**San Francisco Bay Area Rapid Transit District**

**Addendum to Final Initial Study/Mitigated Negative  
Declaration for the Hayward Maintenance Complex  
Project**

**COMPONENT REPAIR SHOP—BUILDING 3  
REPLACEMENT**

March 27, 2013

Figure A

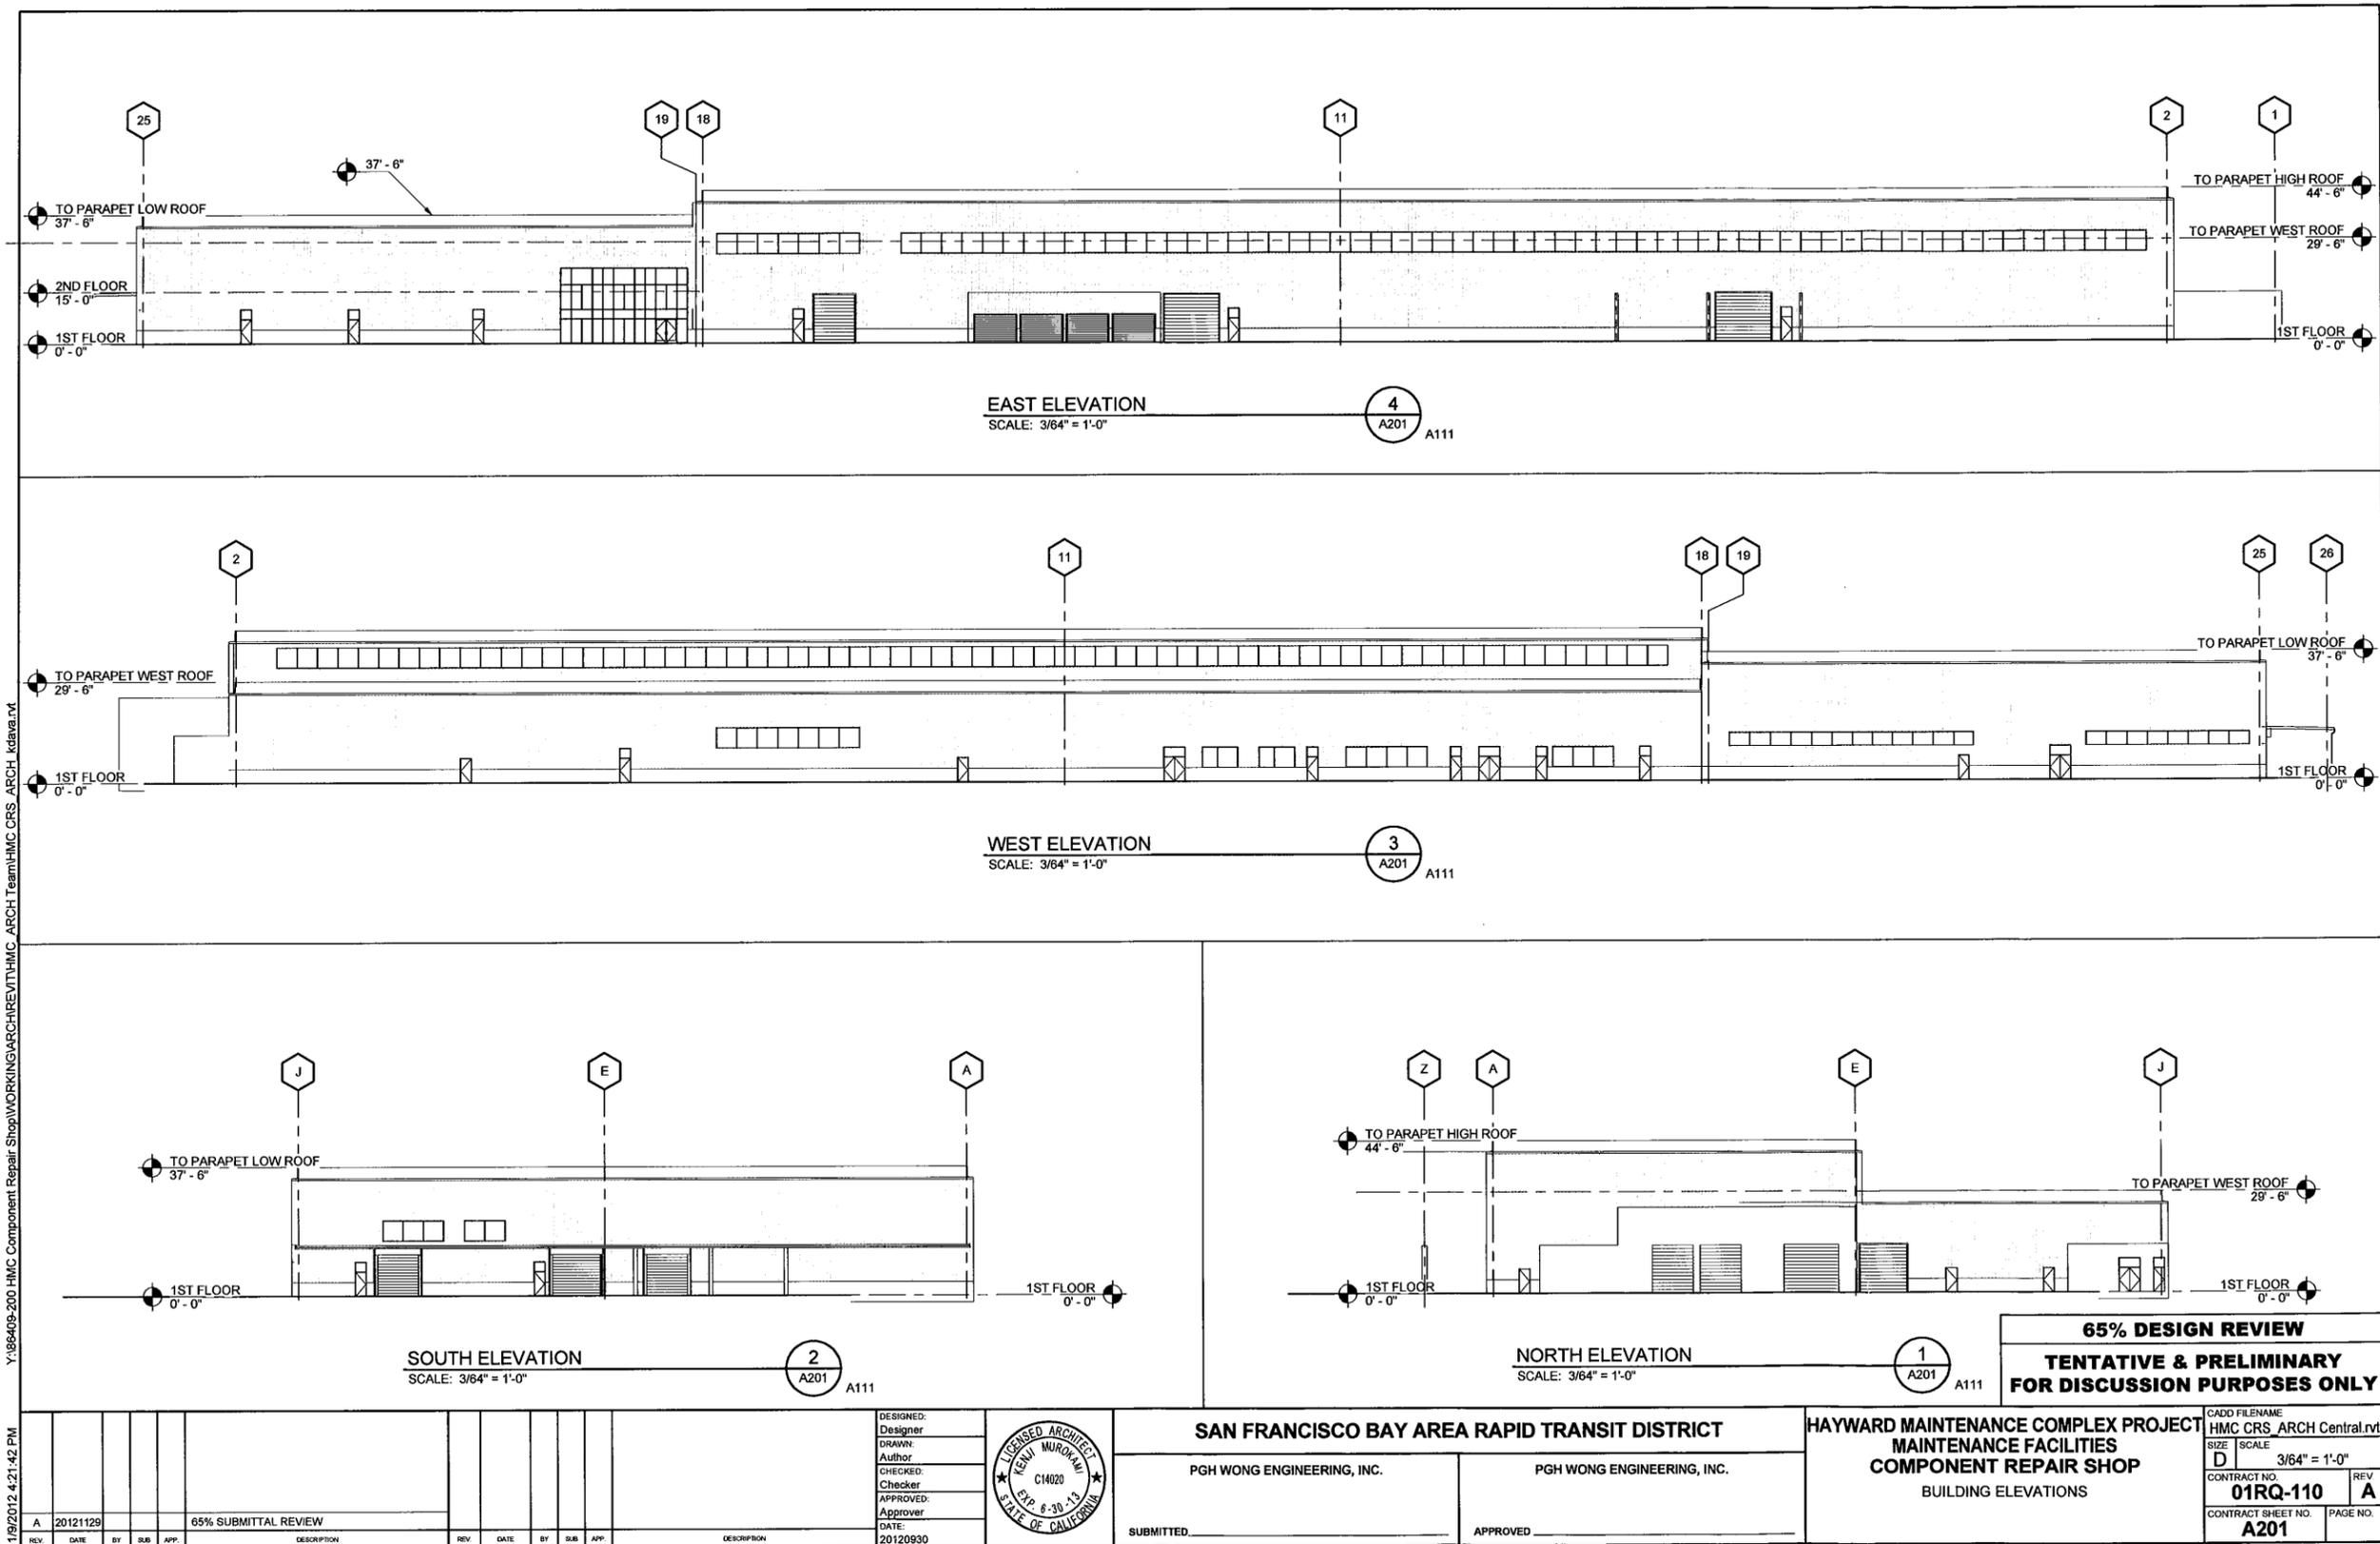
There are four existing warehouses on the west side of the Hayward Yard. (See Figure A.) The northernmost warehouse (Building 4) will to be demolished and replaced by a new overhaul shop. The northernmost of the three retained warehouses (Building 3) was to be renovated to become the Component Repair Shop. The Final IS/MND (page 10, Final IS/MND) described the renovation to the structure as follows:

Therefore, the HMC Project has been modified to demolish Building 3 and replace it with a new structure to house the Component Repair Shop.

The new structure would be shifted 20 feet to the south of its current location. The increased distance will provide additional width to accommodate the north-south roadway and an easement for a relocated water line as well as other utilities between the new Vehicle Repair Shop and the Component Repair Shop. The roadway was described in the IS/MND and would connect the existing driveway serving the west side of the HMC project to Sandoval Way and the Hayward Main Shop area. This southward shift would reduce the distance between the Component Repair Shop and adjacent structure on the south, Building 2, from 100 feet to 80 feet. The new building would be a structural steel frame building clad with metal panels. The new structure would be higher than the 26-foot-tall existing structure. The new building roof line would vary in height, with three different roof levels of 30 feet, 38 feet and 45 feet. (See Elevations, Figure B.) The Component Repair equipment and operations within the building would be the same as originally proposed. The number of employees in the Component Repair Shop would stay the same as originally proposed in the IS/MND (75 during peak occupancy, 150 total).

**HAYWARD MAINTENANCE COMPLEX PROJECT**  
**MAINTENANCE FACILITIES**  
**COMPONENT REPAIR SHOP**  
 NORTH & SOUTH ELEVATIONS

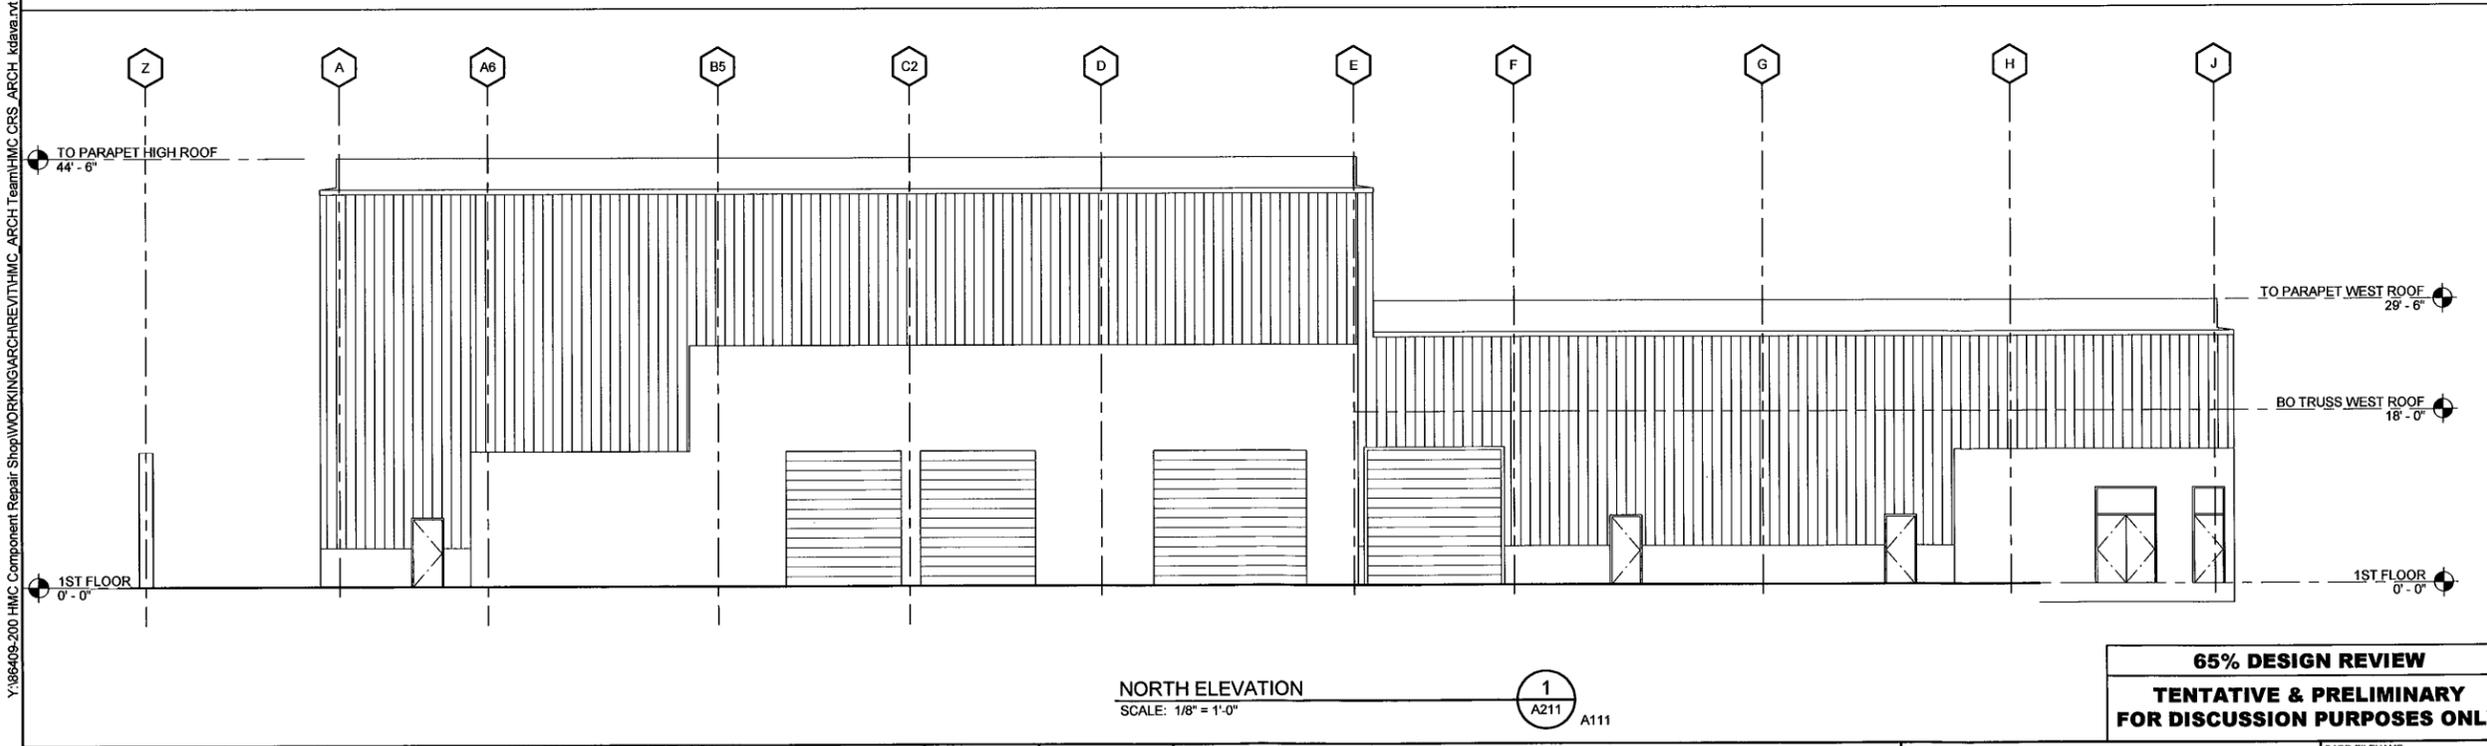
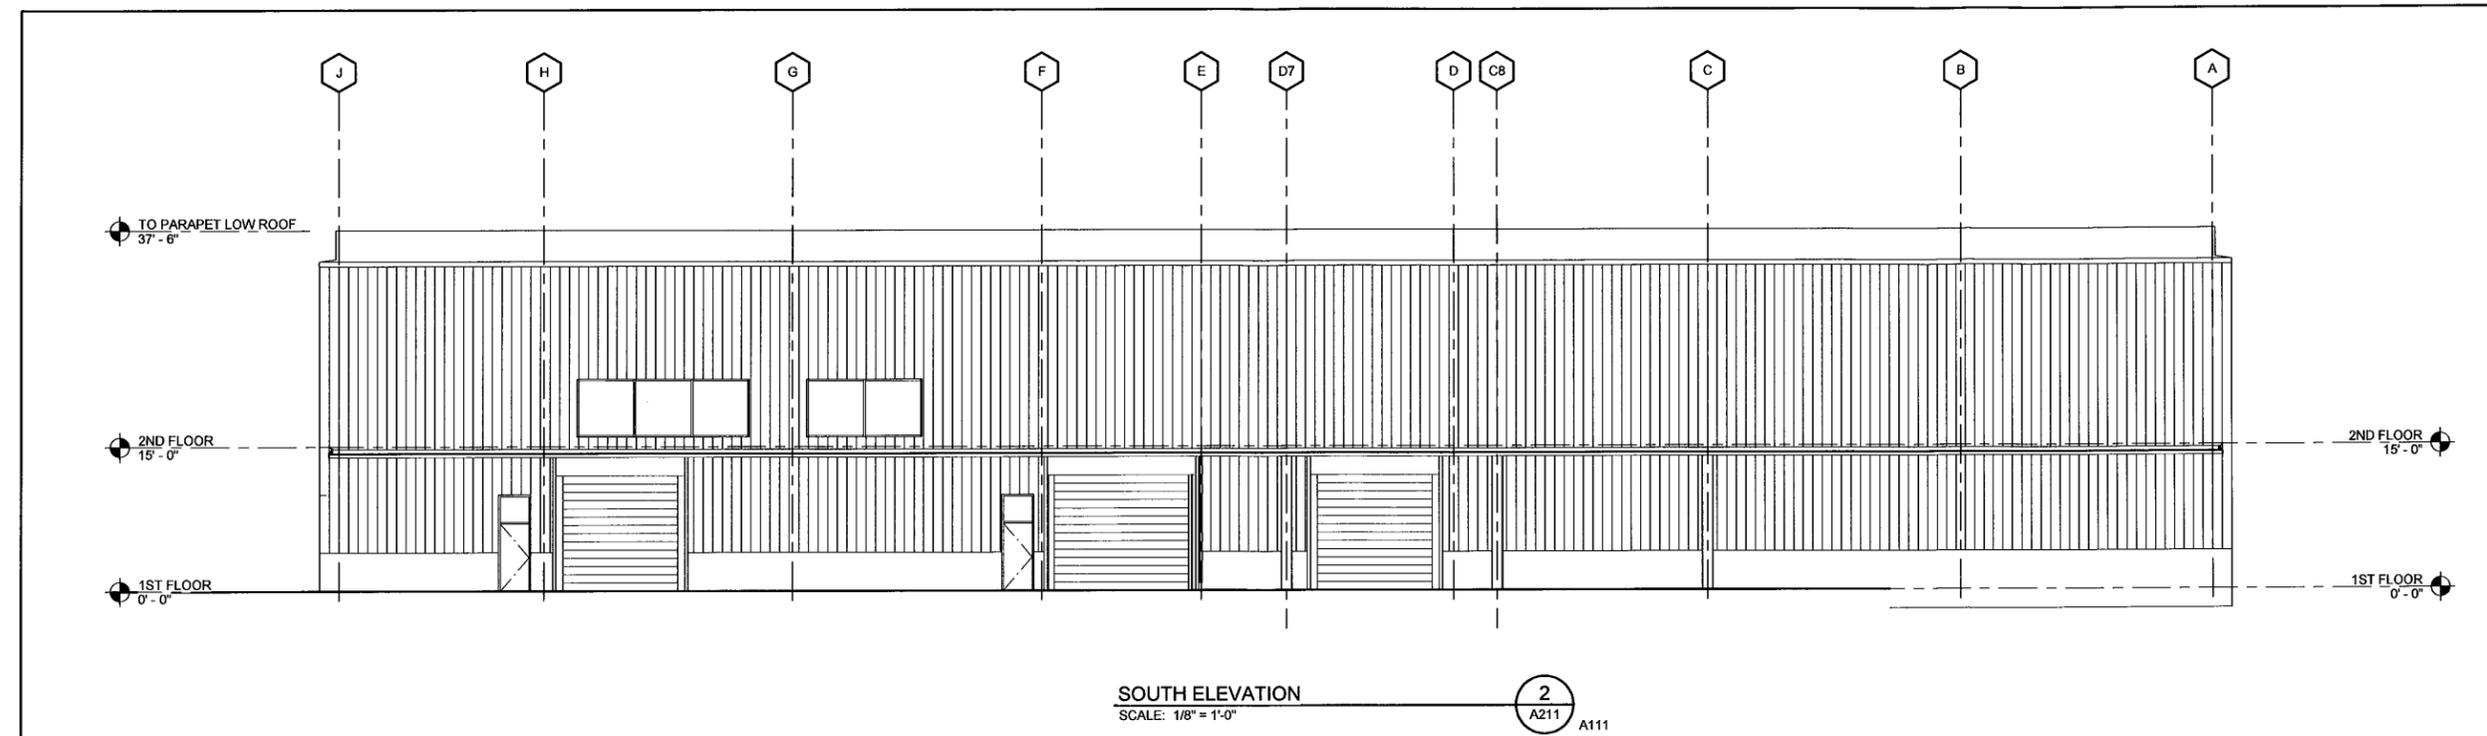
***Aesthetics:*** The new structure would be the same basic footprint and horizontal dimensions as the existing structure, and the building would be shifted 20 feet to the south. The original HMC plan called for raising the roof of the building by from 25 feet to approximately 35 feet. The revised plan would construct a new building with three different roof levels, but with a maximum height of 45 feet. The new building would be a steel frame building with metal panels for walls, similar to the construction of the Hayward Main Shop. As noted in the Aesthetics section of the IS/MND, the west side of the HMC Project is surrounded by industrial uses. The BART mainline tracks are to the east, the Union Pacific Railroad is to the west, and there are other industrial buildings to both the north and south. There are no immediate views of the area from locations open to the public. Given the relatively minor increase in size and height of the new structure compared to the existing building and other existing structures, its 20-foot shift to the south, and the site's lack of visual access, there would be no change to the determination in IS/MND that there is a less than significant visual impact.
